# Service Bulletin

Bulletin No.: PIT6473E

**Subject: Service Forward Collision / Forward Collision Unavailable Messages / Automatic High Beams Inop / Camera Only Learns to 94% / U3000**

7050857

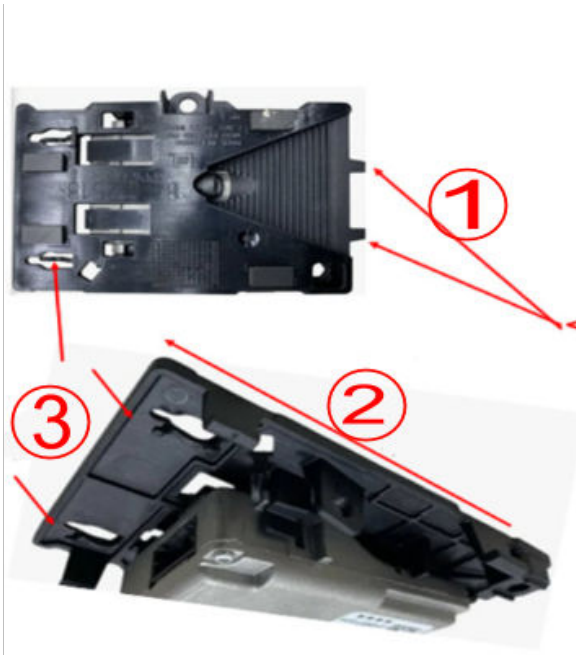
STEP 2. Remove B174W FVCM brackets from interior windshield (refer to pictures below).

STEP 8. Reinstall the FVCM bracket, FVCM, mirror and trim. (review and inspect the FVCM tabs to ensure they are properly seated).

- 1) Alignment tabs
- 2) Push in direction of arrow to release lift tabs
- 3) Lift tabs
